Porsche Cars North America, Inc.  
Michael Scott, Director Regulatory Affairs  
One Porsche Drive  
Atlanta, GA 30354  
Telephone: 770-290-2726  
Email: michael.scott@porsche.us

**Comments to the Notice of Proposed Rulemaking for the Multi-pollutant Emissions Standards for Model Years 2027 and Later Light-Duty and Medium-Duty Vehicles**

EPA-HQ-OAR-2022-0829

Figure 1 EPA designated PM nonattainment zones (From Section 8 DRIA)

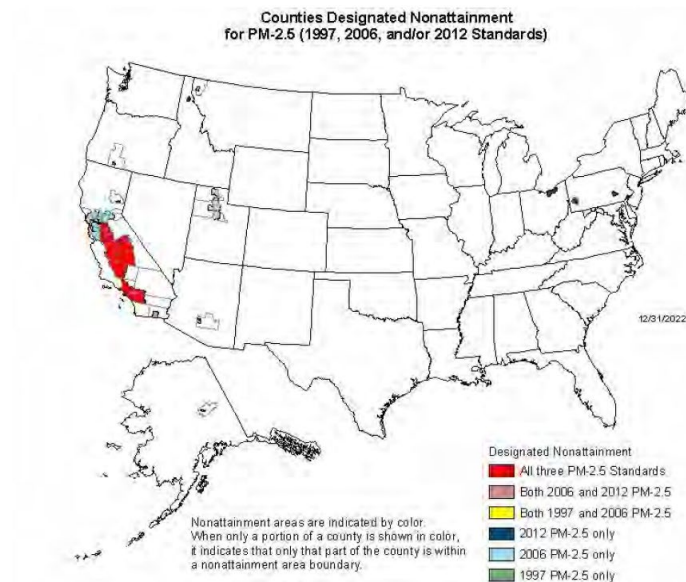
Porsche does not support the adoption of EPA's proposal for 0.5mg PM standard starting in MY2027. As outlined in AFAC comments, Porsche does not understand the basis for this acceleration in Federal PM policy especially given California's recent LEV-IV rulemaking which reaffirmed and retained California's previously adopted LEV-III PM roadmap of 1.0mg. Relative to the potential costs and implementation challenges that this all-new proposal could create, it is unclear of the incremental value that EPA's proposal seeks to achieve by surpassing standards that California confirmed as being effective and appropriate in reducing PM. This is especially important considering California being the state which has the most prevalent challenges with PM emissions nationwide. Considering the overall transition towards electrification, the long-standing 1.0mg policy of California, the uncertainty regarding measurement and certification reliability, and in the minority role that new light-duty vehicles play in the overall PM inventory, Porsche is not supportive of EPA's PM proposal. Instead, Porsche recommends EPA transition to adopt the LEV-III 1.0mg in the timing and context of Tier-4.

As shown in Figure 8.1 of the DRIA (captured below in Figure 1), EPA illustrates the counties which are in nonattainment with the variety of PM standards. EPA makes note of the estimated populations that live within these various counties, however as shown in the illustration below, the vast majority of that population likely reside in California and in several States that already follow California motor vehicle emissions regulations (i.e., Pennsylvania, Oregon, Washington State). Very few of the states with counties highlighted below are in Federal emissions states. As noted previously, the states who are shown in this figure as having the highest proportion of challenges with PM attainment, were the States who maintained the 1.0mg PM roadmap in LEV-III.

Figure 2 EPA FTP test procedure flow-chart from 1066.801

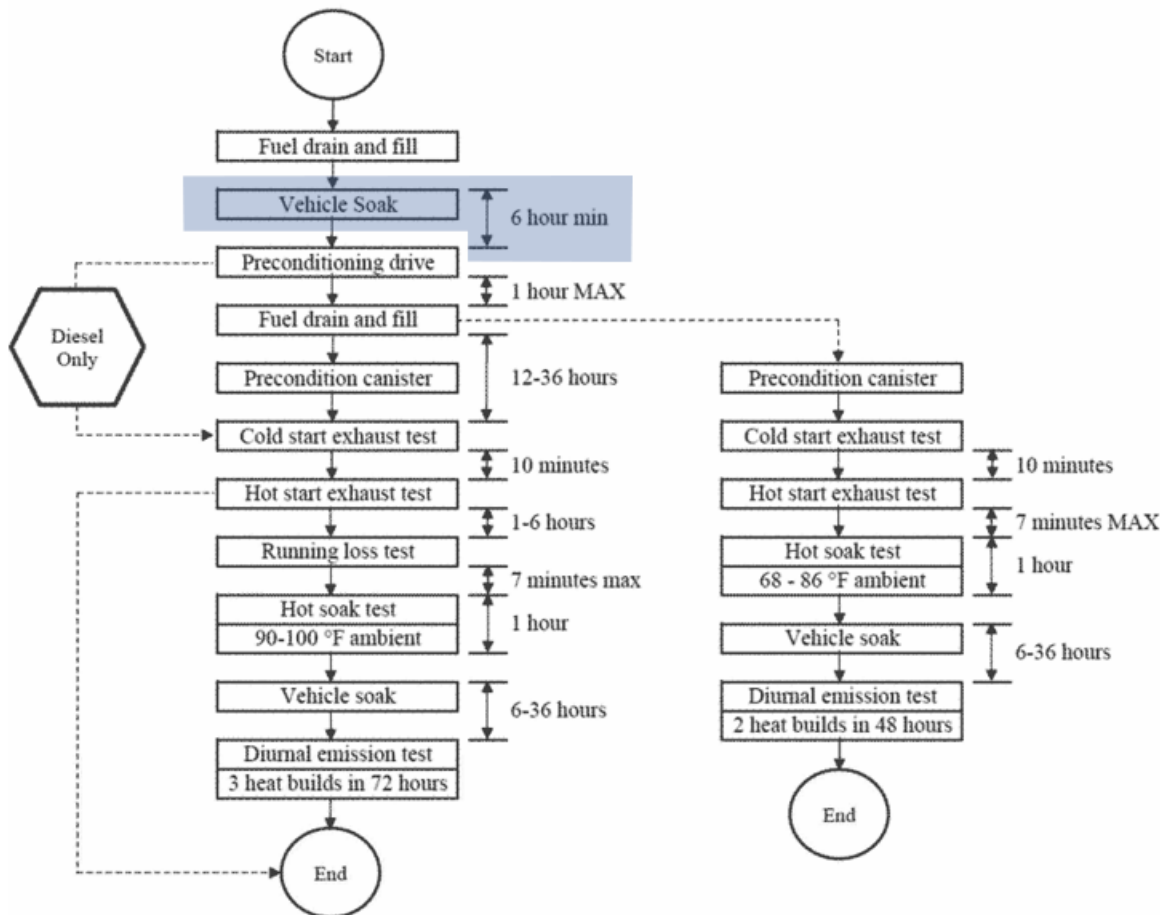
# **10. Porsche recommends streamlining the FTP test procedure to remove the initial 6-hour minimum vehicle soak.**

In identifying further opportunities for test streamlining, Porsche reviewed the FTP test procedure flow-chart illustrated in 1066.801(e) and analyzed the relevancy of the initial 6-hour minimum soak period that follows the initial drain-and-fill. Porsche understands that the specific role of this initial 6-hour minimum soak period may have been to account for the possibility that fuel added to the vehicle could have been stored at different temperatures than the vehicle, for example if the fuel was in an underground tank. Or if the vehicle itself was stored at a temperature outside of the lab temperature and needed time to stabilize prior to preconditioning. In situations where the vehicle and fuel are otherwise already stabilized, it is unclear if this initial soak is relevant. Porsche recommends that EPA provide flexibility to manufacturers to use good engineering judgement to determine if the initial 6-hour minimum soak period can be skipped in order to help improve test facility efficiencies. Porsche recognizes that EPA, specific to confirmatory testing, would continue to use the 6-hour minimum soak period in order to have a consistent confirmatory process.
